Site: Guardian Storage-La Orilla

The following violation was observed at today's inspection.

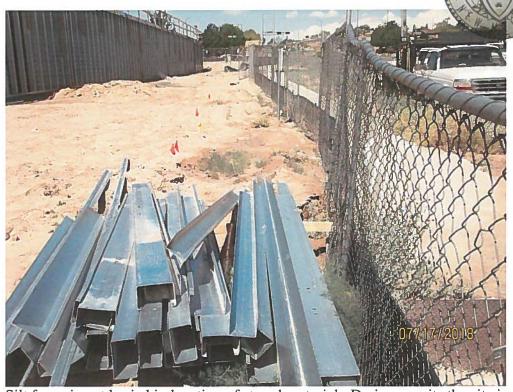
Wash-out in north area of site.

Silt fence is not buried in location of stored material. Drainage exits the site in this location.

- 1. Remove trash that has left the site and trash in the SE area that could leave the site. Deposit trash into an appropriate container.
- 2. Remove track-out from Lo Orilla Rd. It extends up to Coors Blvd
- 3. Remove sediment from Bosque Plaza Lane.
- 4. Perform maintenance/replace the track-out pad.
- 5. Remove the cement material from La Orilla Rd and Bosque Plaza Lane. Material is not to be washed into the bosque. An aqueous solution or similar may be used to help remove it, but it must be captured/treated.
- 6. Replace the section of silt fence that was apparently removed for the delivery of cement.
- 7. Remove the wash-out from the dirt.
- 8. Provide an acceptable wash-out facility onsite and have workers use it.
- 9. Maintain the silt fence in the northeast corner so it is buried. Stormwater quality recommends diverting drainage away from this location.
